Re: Brown County Landfill Cell #4 Construction
Helms A-7653

ADDENDUM NUMBER 1

The following modifications are made to the plans and specifications for the Brown County Landfill Cell #4 Construction.

FUTURE SITE LAYOUT SHEET

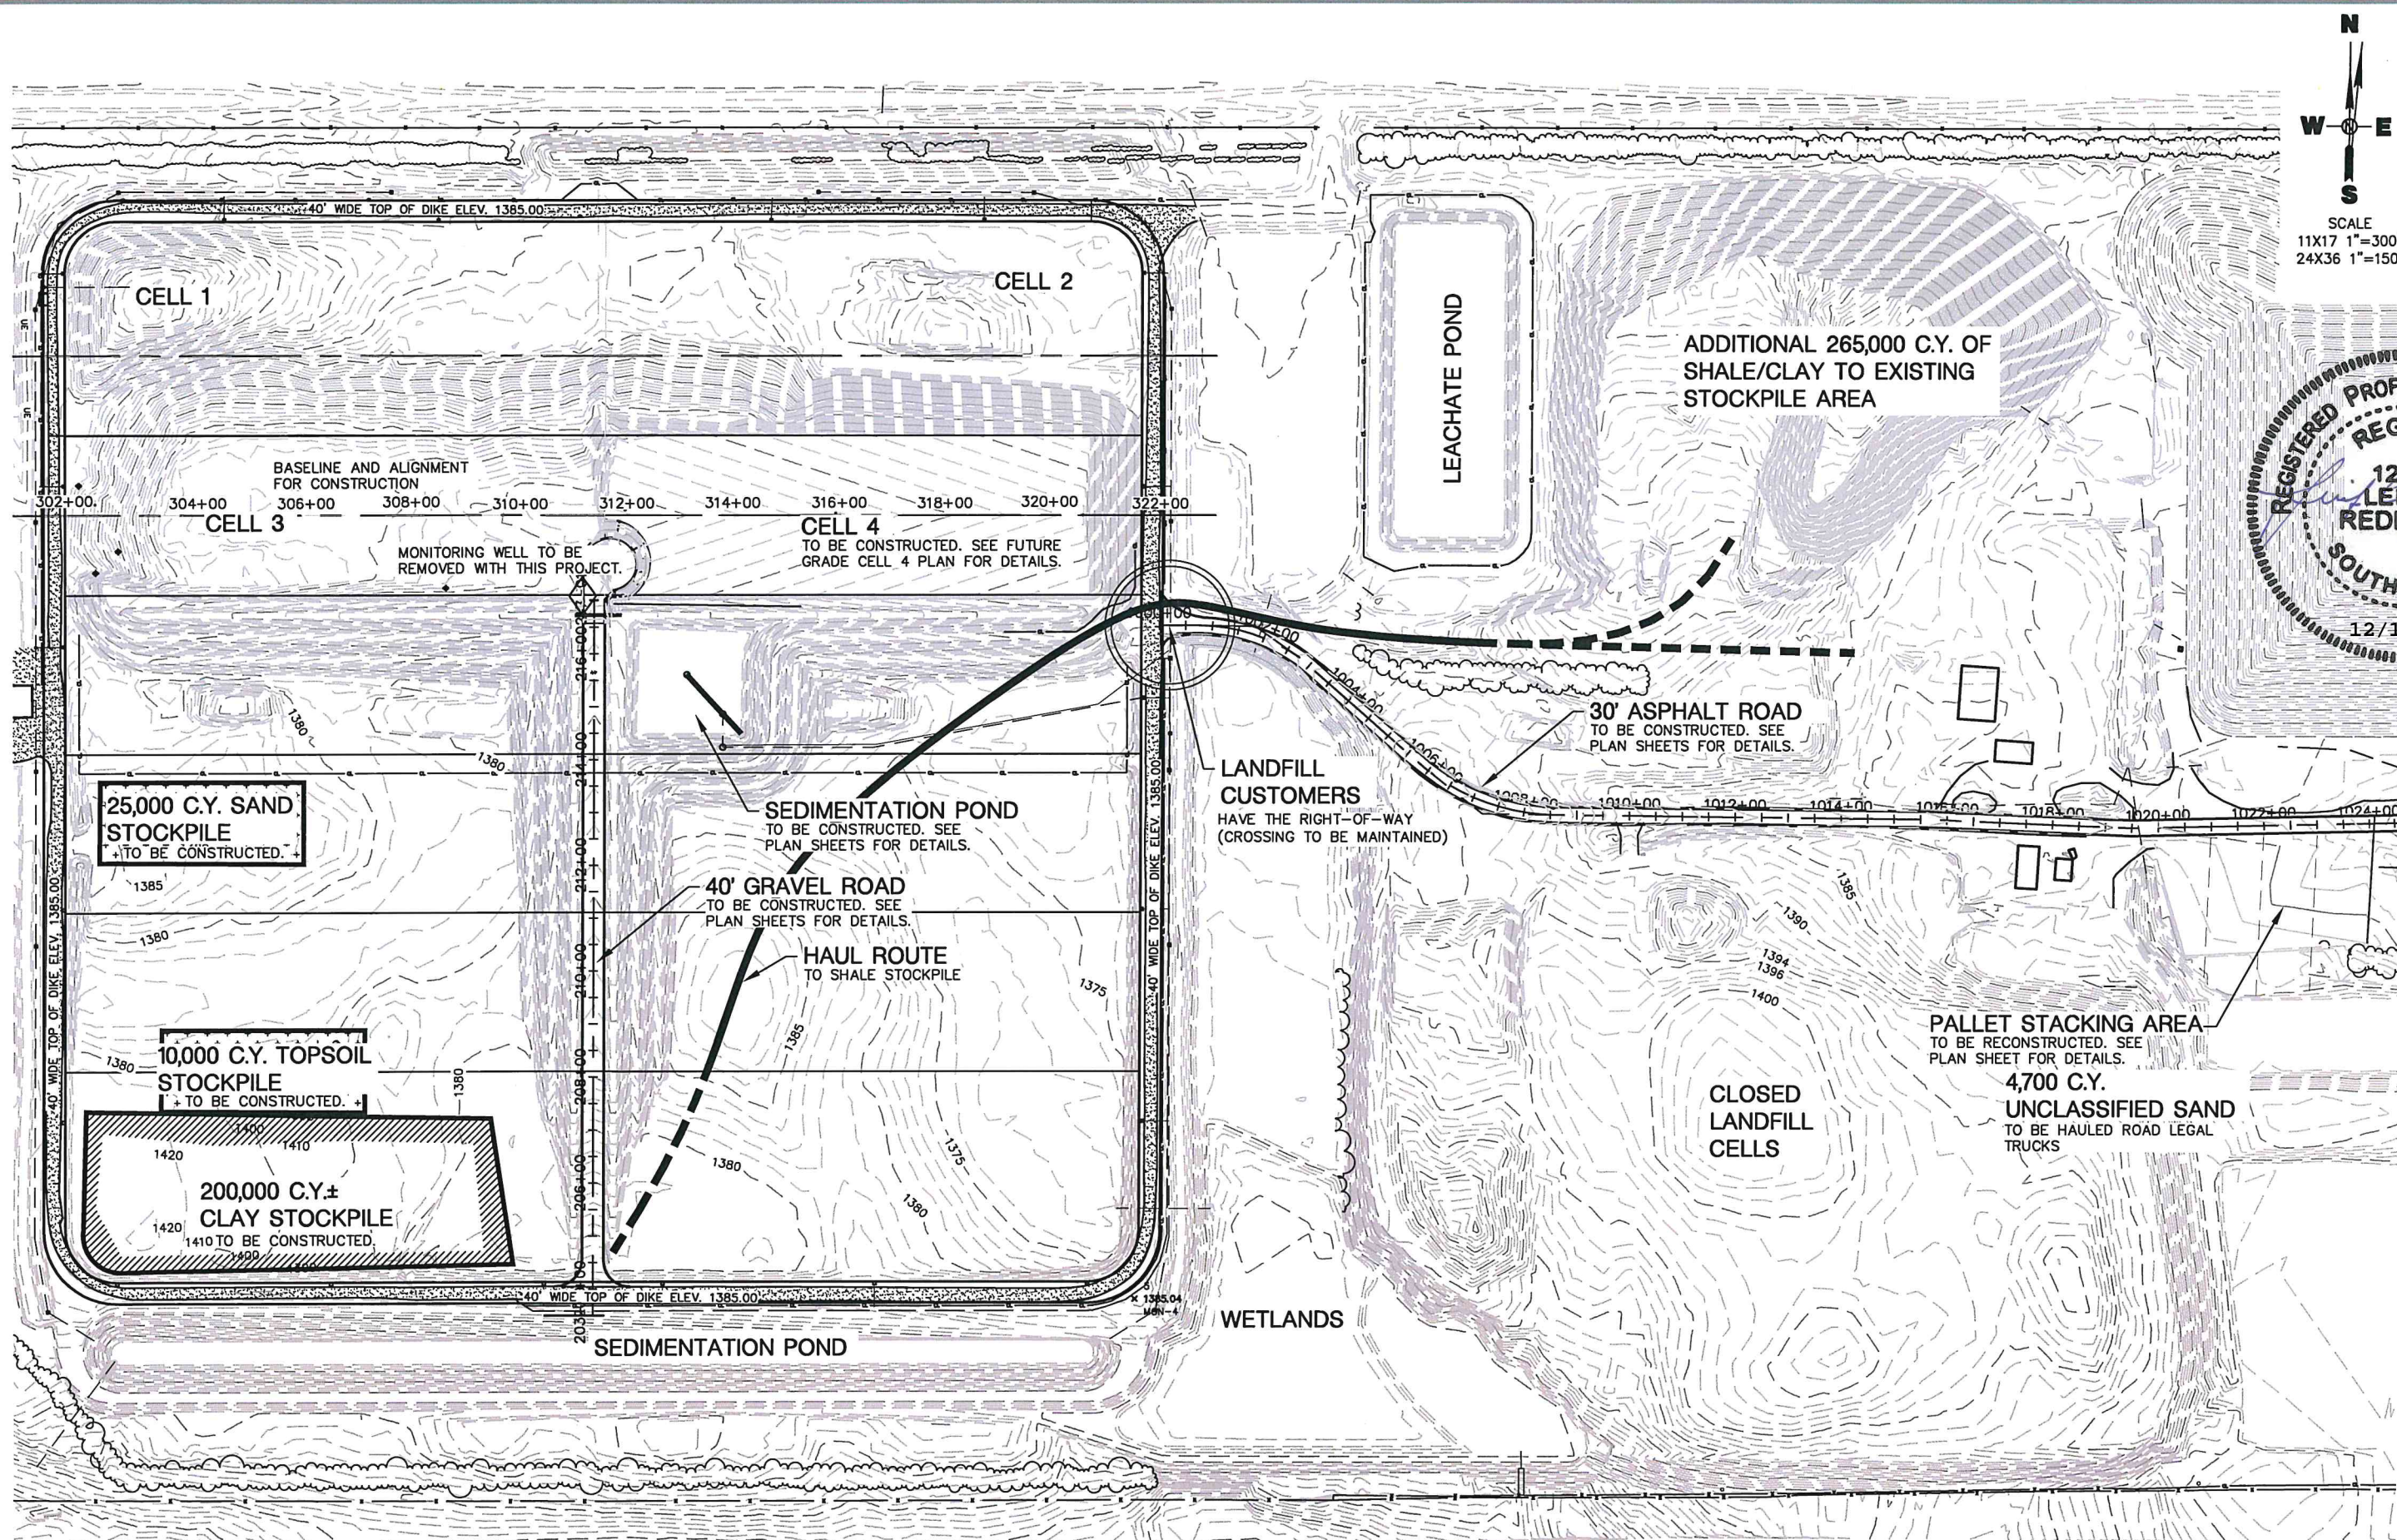
2. Replace Sheet 5 with revised sheet attached.

Revised version includes the addition of specified haul route to shale stockpile and estimated quantities for the various unclassified excavation stockpiles and their locations.
